Project	IEEE 802.16 Broadband Wireless Access Working Group < <a href="http://ieee802.org/16">http://ieee802.org/16</a> >	
Title	Consideration on CX-Frame backward compatibility	
Date Submitted	2007-09-07	
Source(s)	<p>Shulan Feng Hisilicon Tech. Co., LTD Bld.17, No.8, Dongbeiwang West Road, Hai-Dian District, Beijing, P. R. China</p> <p>Wu Xuyong Huawei, Huawei Industry Base, Bantian, Longgang, Shenzhen, China 518129</p>	<p>Voice: +86-10-82829151 Fax: +86-10-82829075 e-mail to : <a href="mailto:fengsl@hisilicon.com">fengsl@hisilicon.com</a> , <a href="mailto:fengsl@huawei.com">fengsl@huawei.com</a></p> <p>Voice: +86-755-28976776 Fax: E-mail to : <a href="mailto:wuxuyong@huawei.com">wuxuyong@huawei.com</a>,</p>
Re:	IEEE 80216h-07/019	
Abstract	This contribution analysis the backward compatibility problem of CX-Frame and gives the solution which could be get better backward compatibility.	
Purpose	Accept.

# Consideration on CX-Frame backward compatibility

IEEE C802.16h-07/083

Figure 1

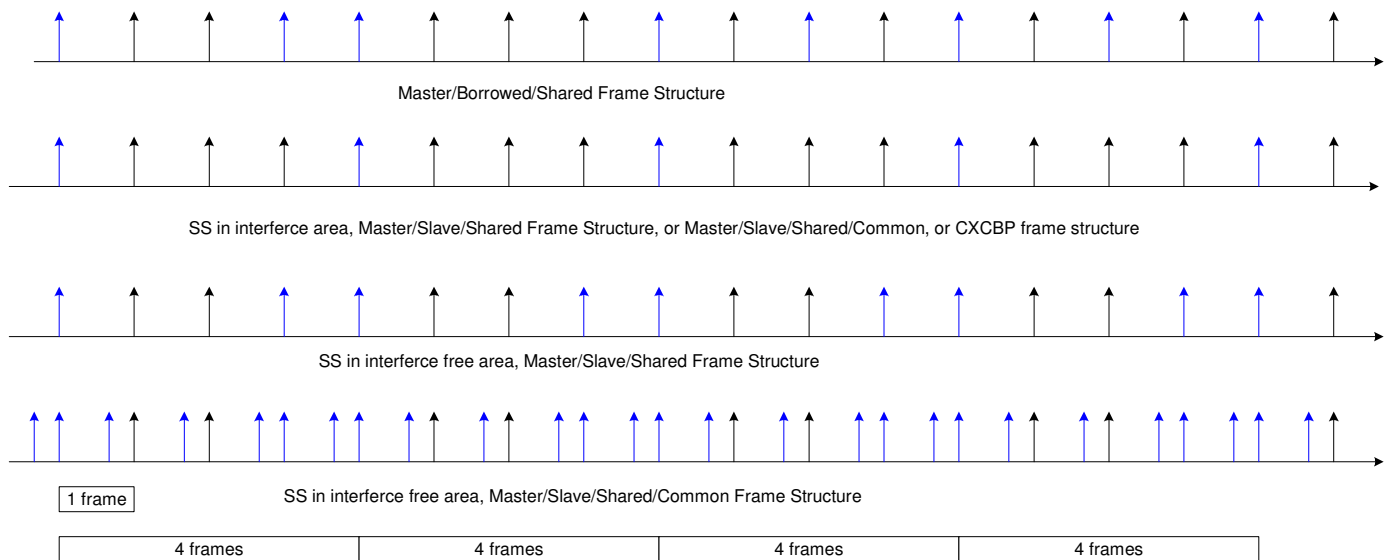
In all these CX-Frame structure, preamble and MAP are transmitted every subframe and frame. Then SS in interference free area may receive more than one preamble and MAP in one frame. And SS in interference area can't receive any preamble and MAP during some frames. The following figure shows one example in case of three systems sharing one channel. Blue arrows indicate the preambles SS can receive. Black arrows indicate the preambles that SS can't receive.

Non-periodic preamble and MAP make the PHY change corresponding to legacy standard and make SSs hard to perform synchronization. More than four types of CX-Frame structures further make the situation worse. To get good compatible to legacy standard, preamble and MAP had better to be transmitted fixed and periodic. Considering in CX-Frame structure, all SSs can communicate with its serving BS's during master

subframe/frame. And the master subframes are periodic. So we propose preamble and MAP are transmitted once every CX-Frame and they are transmitted only in master subframes. That is, the MAP in master subframes includes the resource allocation MAP of shared frame, borrowed frame, CXCBP frame and common subframe. SSs in interference area will be scheduled to master subframe and SSs in interference free area can be scheduled to any of subframe.
